**Subject: Safety Recall 99V-029 NSA-111paw
(Ford Number 99S02)**

SUBJECT: Safety Recall 99S02 - All 1992 through 1997 Model Year Aerostar Vehicles - Accessory Power Circuit

SUBJECT: Safety Recall 99S02, Supplement #1 - All 1992 through 1997 Model Year Aerostar Vehicles - Accessory Power Circuit, Service Kit Part Number Revision, Manual Transmission Recall Service Procedure

RECALL TECHNICAL INSTRUCTION REVISIONS

FIGURE 5

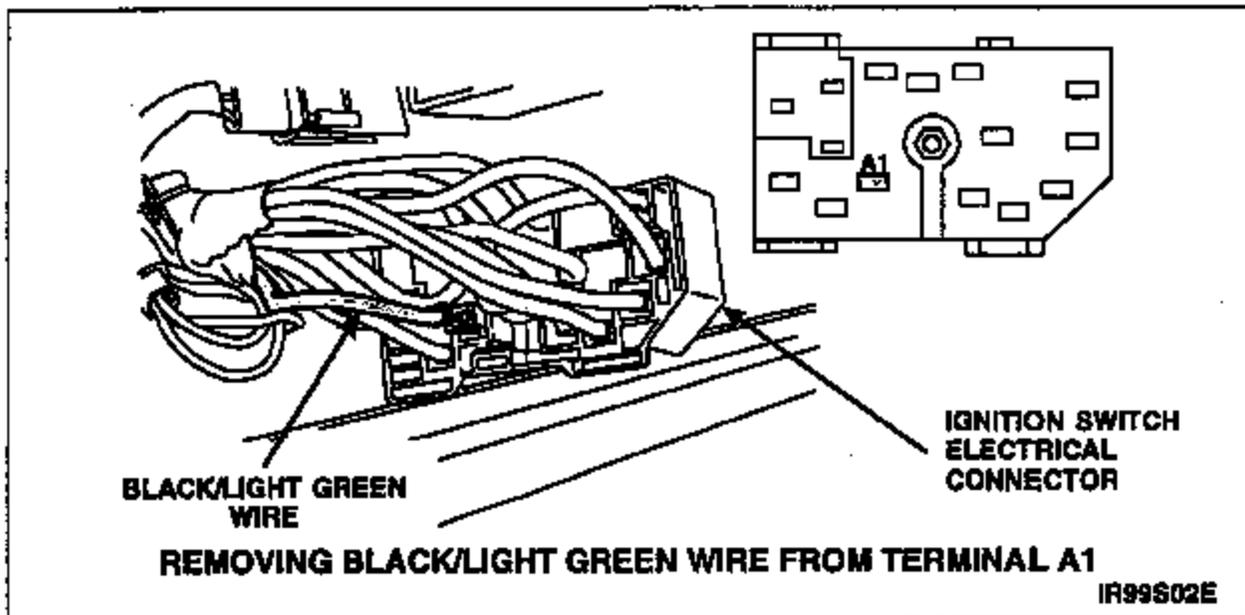
7. Remove black/light green wire, circuit 297, from terminal A1 of ignition switch electrical connector. See Figure 5.

7. Remove the gray/yellow wire, circuit 687, from terminal A3 of the ignition switch electrical connector. See Figure 5.

FIGURE 6

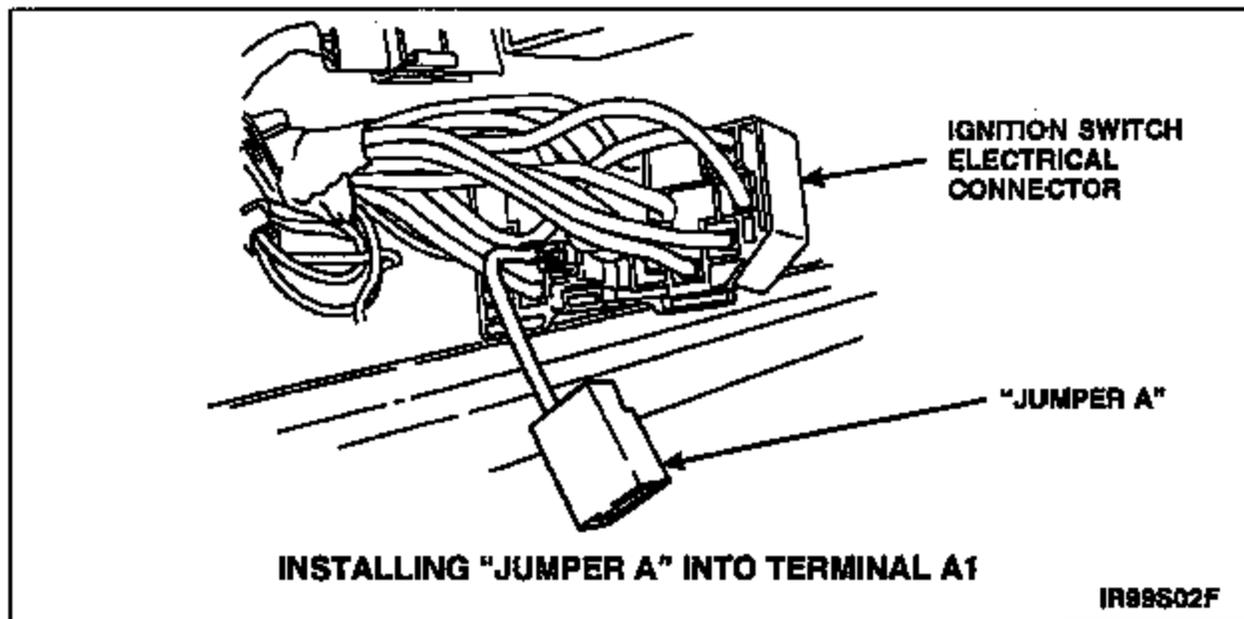
8. Install black/light green wire of "Jumper A" into terminal A1 of ignition switch electrical connector. See Figure 6.

8. Install the black/light green wire of "Jumper A" into terminal A3 of the ignition switch electrical connector. See Figure 6.

FIGURE 5

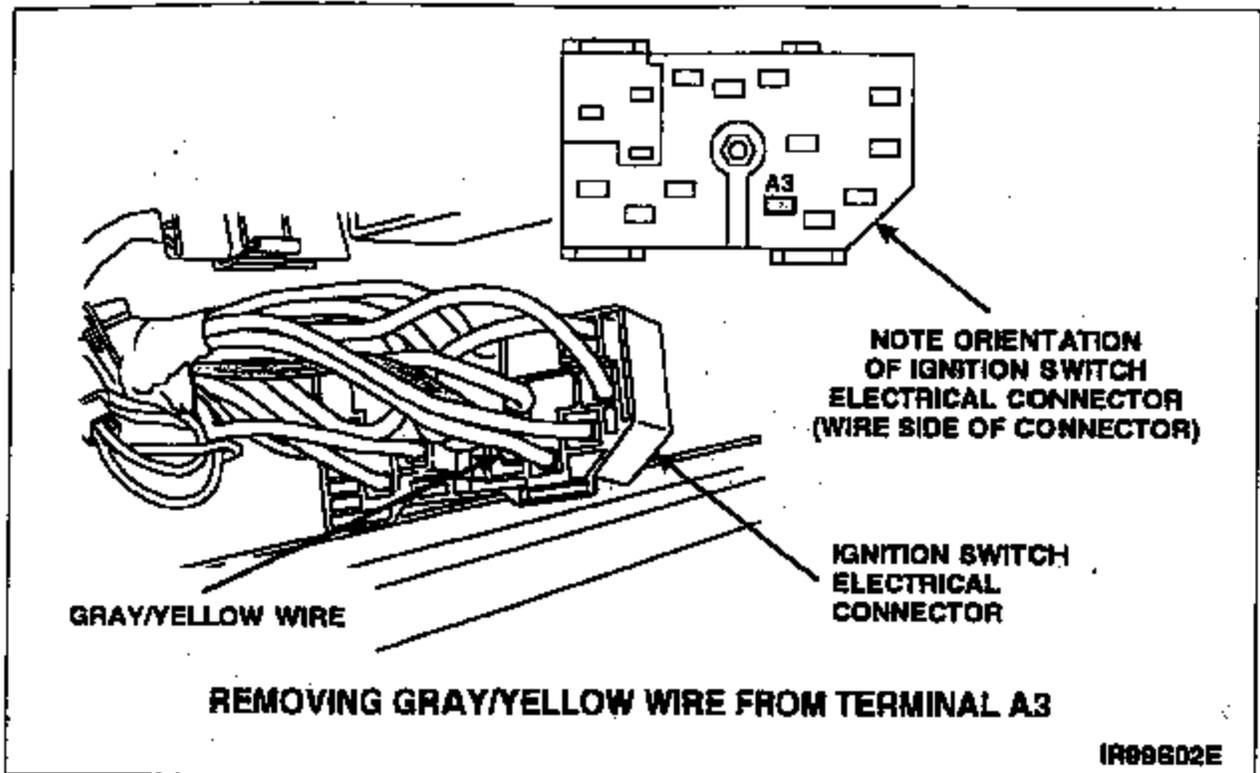
Step # 7. - Revised circuit used for relay installation from A1 to A3.

FIGURE 6

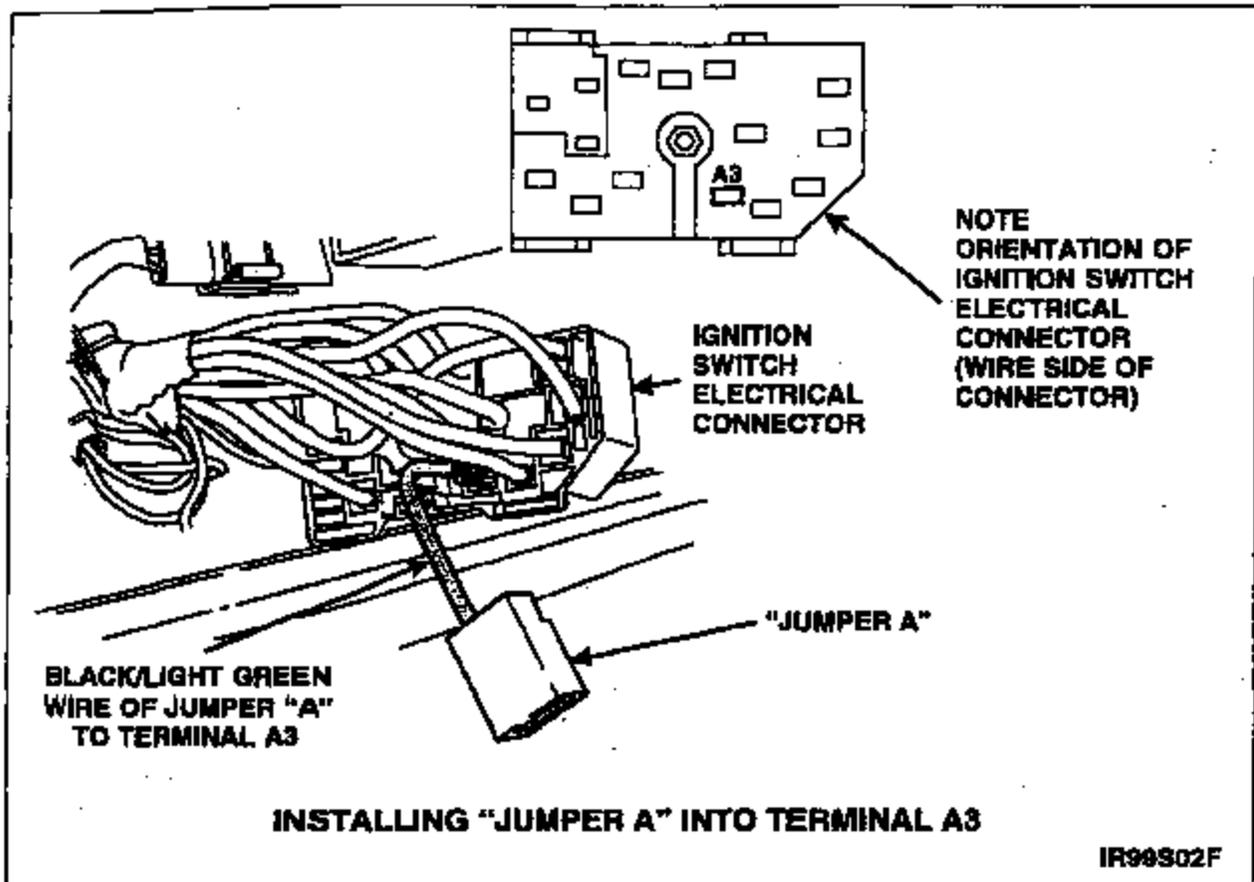
Step # 8. - Circuit A3 used for "Jumper A" installation.

FIGURE 12

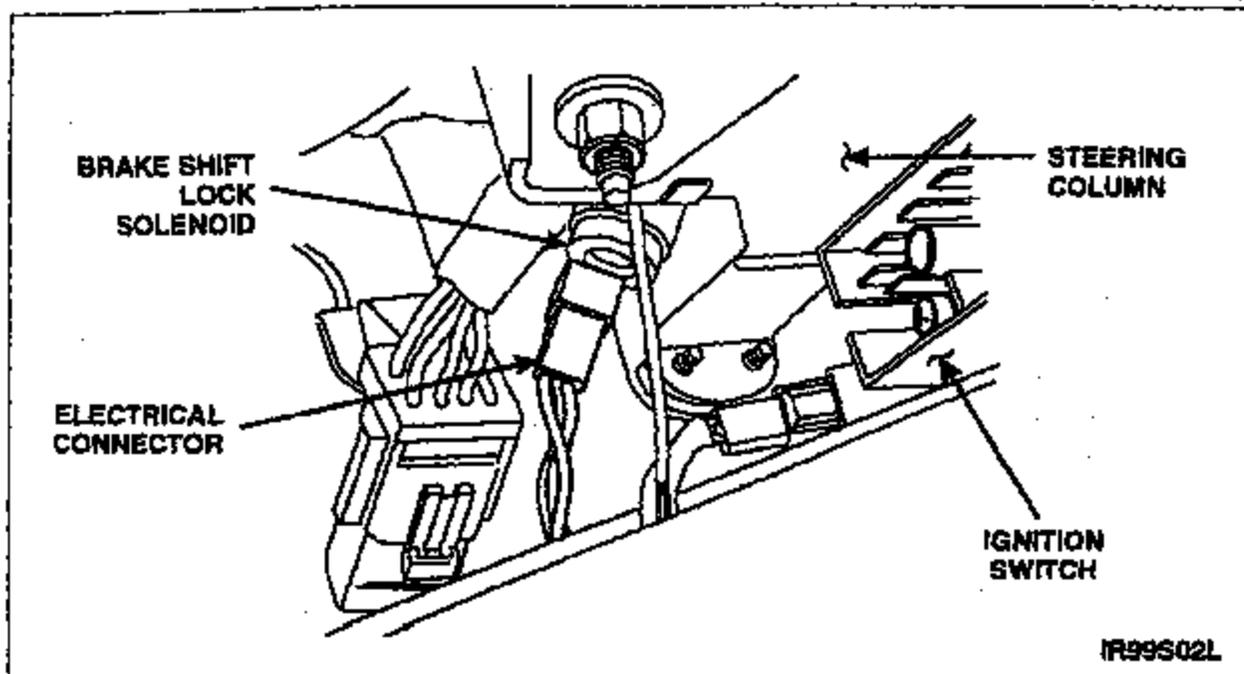
Step # 15. - Addresses the location of the brake shift interlock solenoid electrical connector for manual transmission equipped vehicles

14. Install the ignition switch electrical connector wiring shield and terminal locking plate.
15. On manual transmission equipped vehicles, locate the unused brake shift lock solenoid electrical connector within the ignition switch wiring harness (under the paper tape). Access the electrical connector by tearing the paper tape (using fingers) on the wiring harness approximately 30 mm (1 inch) from the back of the ignition switch connector.

16. On automatic transmission equipped vehicles, disconnect the electrical connector from the brake shift lock solenoid. See Figure 12.

FIGURE 5

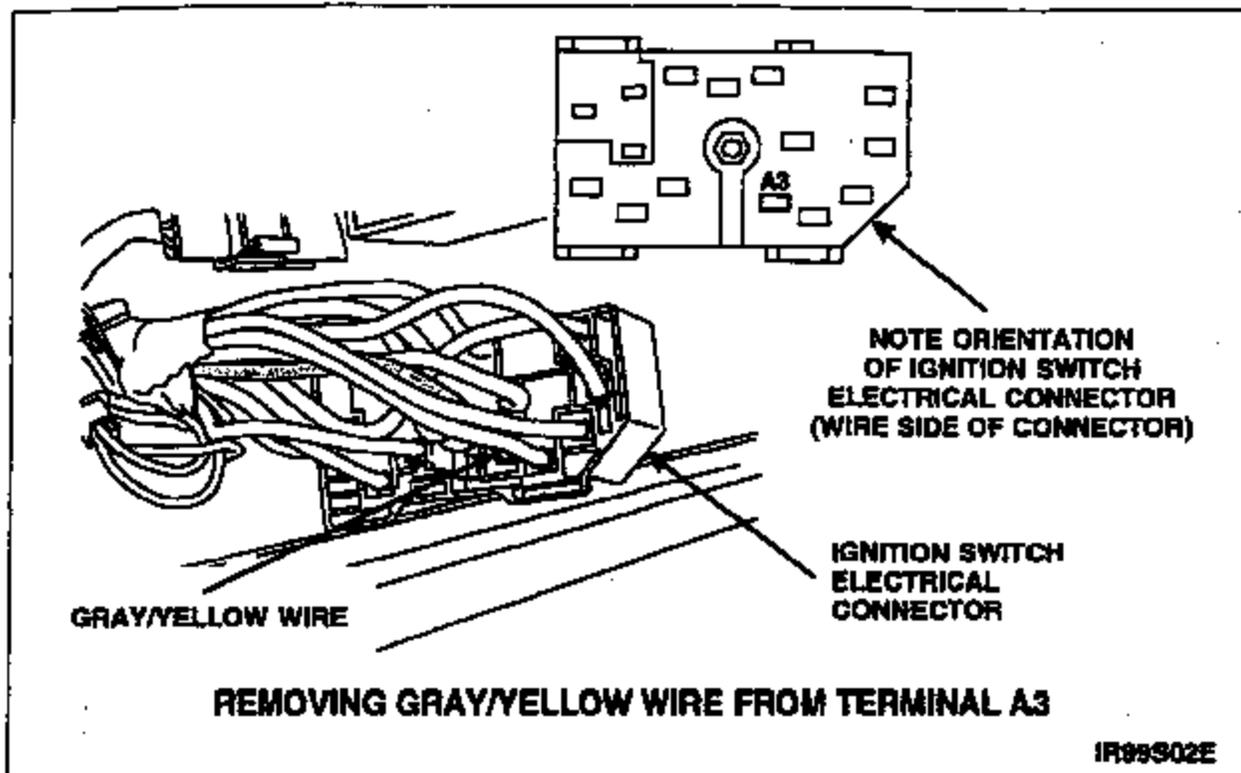
Vehicles repaired using the original Technical Instructions were inadvertently modified to allow the operation of the heater blower, brake shift interlock, rear window defogger, daytime running lamps (DRL) and multi-function switch (windshield wipers) with the key in the ACCESSORY position. Attachment III-b provides information to modify the jumper harness wiring so that the accessory components will be operational only with the key in the RUN position.

7. Remove the gray/yellow wire, circuit 687, from terminal A3 of the ignition switch electrical connector. See Figure 5.

FIGURE 6

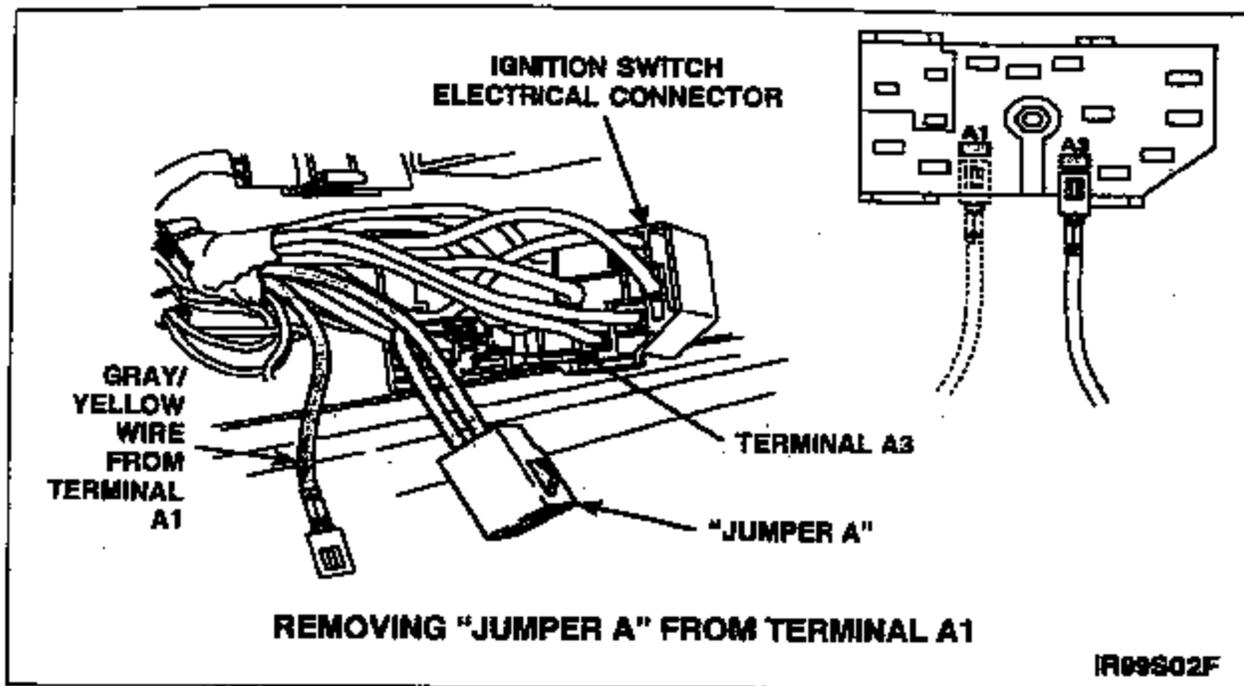
8. Remove jumper A black/light green wire from terminal A1 of the ignition switch connector and install it into terminal A3 of the ignition switch connector. See Figure 6.

FIGURE 8

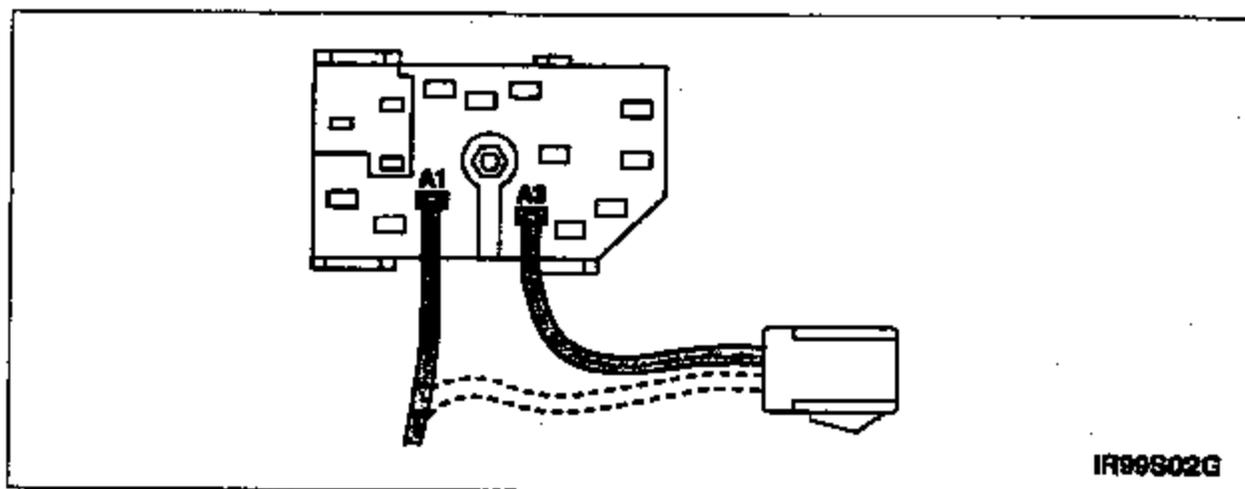
9. Remove the vehicle wiring harness black/light green wire from jumper A and install it into terminal A1 of the ignition switch electrical connector. See Figure 7.

FIGURE 8

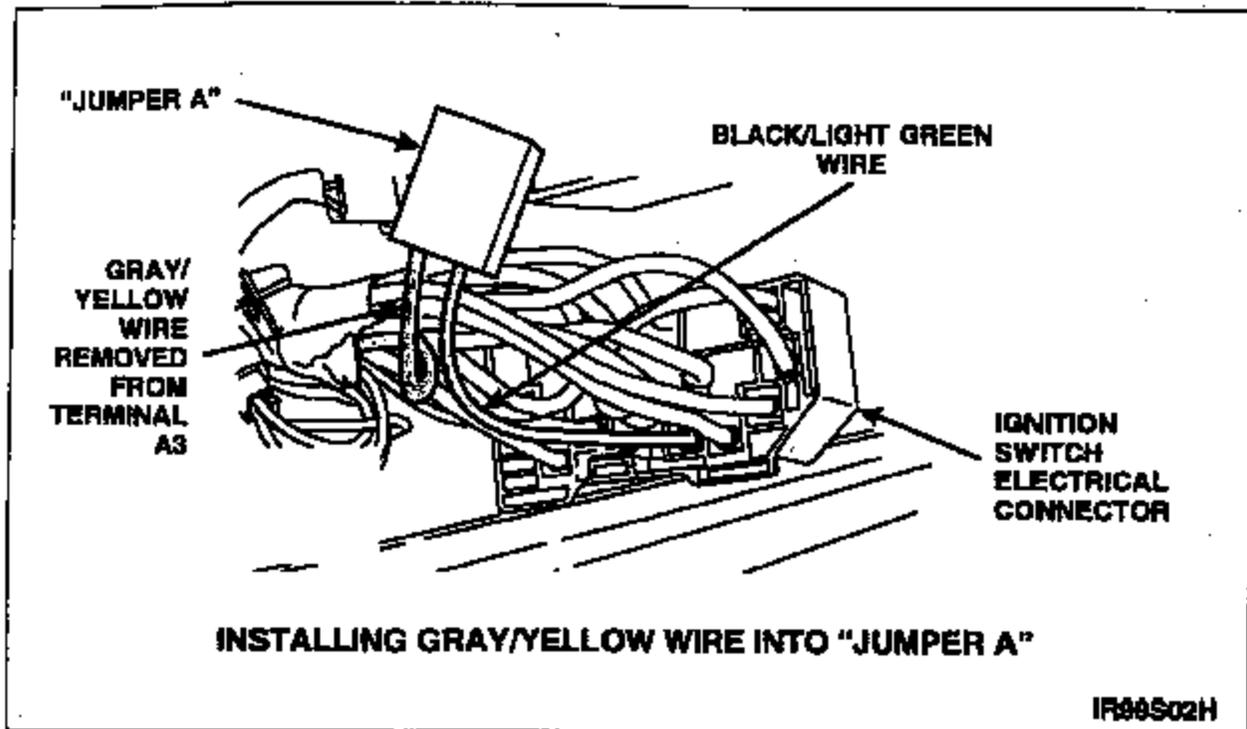
10. Install the gray/yellow wire, circuit 687, previously removed from terminal A3 of the ignition switch electrical connector into the open terminal in jumper A. See Figure 8.
